## Product/Process Change Notice (PCN)

<p><b>PCN Number:</b> PCN_FrqXTAL_20250305</p> <p><b>Affected Series:</b> WE-XTAL</p> <p><b>Affected Part Number:</b> See table below</p> <p><b>PCN Date:</b> 2024-12-05</p> <p><b>Effective Date:</b> 2025-03-05</p>	<p><b>Change Category:</b></p> <p><input type="checkbox"/> Equipment/Location  <input checked="" type="checkbox"/> General Data  <input type="checkbox"/> Material  <input type="checkbox"/> Process  <input type="checkbox"/> Product Design  <input type="checkbox"/> Shipping/Packaging  <input type="checkbox"/> Supplier  <input type="checkbox"/> Software</p>																														
<p><b>Contact:</b> Product Management</p> <p><b>Phone:</b> +49 (0) 7942 - 945 5001</p> <p><b>Fax:</b> +49 (0) 7942 - 945 5179</p> <p><b>E-Mail:</b> pcn.eisos@we-online.com</p>	<p><b>Datasheet Change:</b></p> <p><input checked="" type="checkbox"/> Yes      <input type="checkbox"/> No</p> <p><b>Attachment:</b></p> <p><input type="checkbox"/> Yes      <input checked="" type="checkbox"/> No</p>

4. Correction of the Product Dimensions:

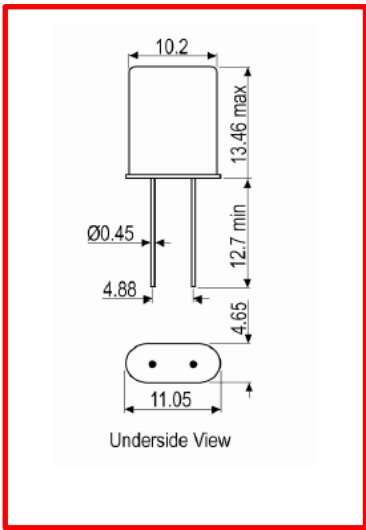
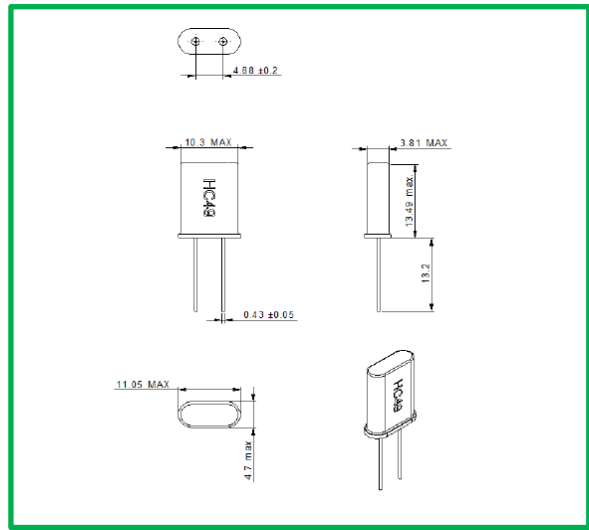
Before	After
Product Dimensions
